## PLAT COMMITTEE

Case Number:	2024-PLT-017
Property Address:	8120 East Southport Road (Approximate Address)
Location:	Franklin Township, Council District #25
Petitioner:	DRGSF Surplus, LLC, by Russell L. Brown and Elizabeth Bentz Williams, AICP
Zoning:	C-3 / C-S
Request:	Approval of a Subdivision Plat to be known as Johnson Fields West Phase III, dividing 8.43 acres into four lots and one common area.
Waiver Requested:	None
Current Land Use:	Vacant single-family dwelling
Staff Reviewer:	Jeffrey York, Principal Planner I

Proposed plat

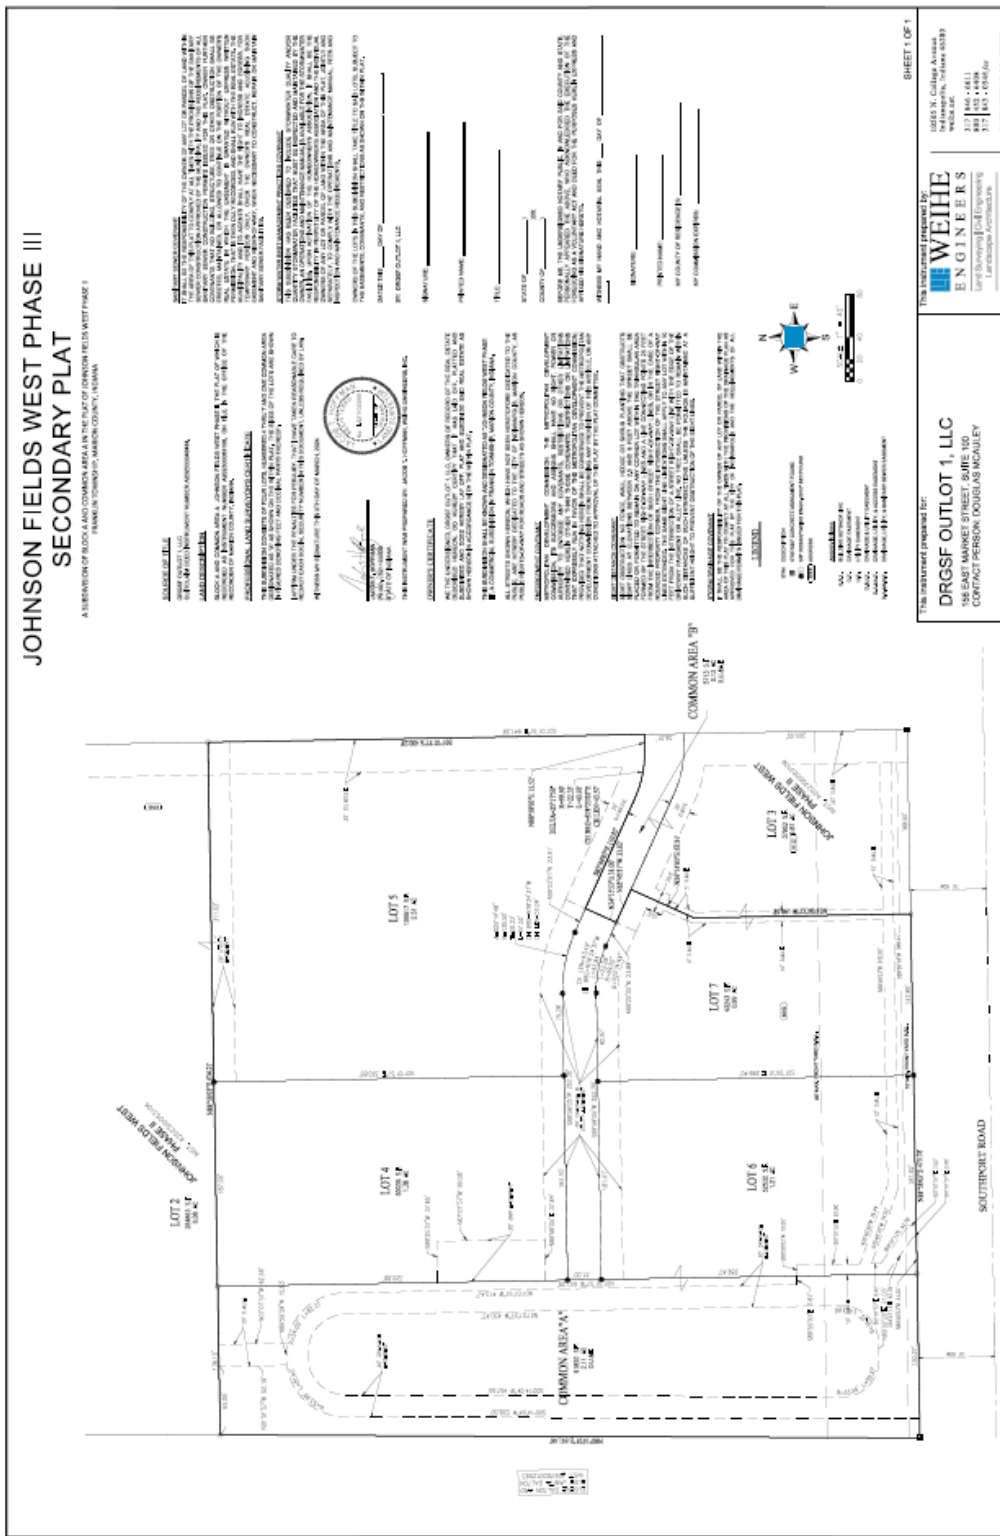
This proposed plat would divide Block “A”, that was set out in 2023-PLT-035, into four lots. This plat also includes Common Area “A” that was part of 2023-PLT-035. Common Area “A” would not change from its original size of 2.11 acres.

The site is zoned C-3 and C-S and would be an expansion of the large integrated center to the east. The request would allow for future commercial development under the C-3 and C-S classifications. The proposed subdivision meets the standards of the Subdivision Regulations, the C-3 district and C-S district and commitments from rezoning petitions 2014-CZN-824B, C, and D.

Staff recommends that the Plat Committee **approve** and find that the plat, file-dated March 1, 2024, complies with the standards of the Subdivision regulations, subject to the following conditions:

1. That the applicant provides a bond, as required by Section 741-210, of the Consolidated Zoning and Subdivision Ordinance.
2. Subject to the Standards and Specifications of Citizens Energy Group, Sanitation Section.
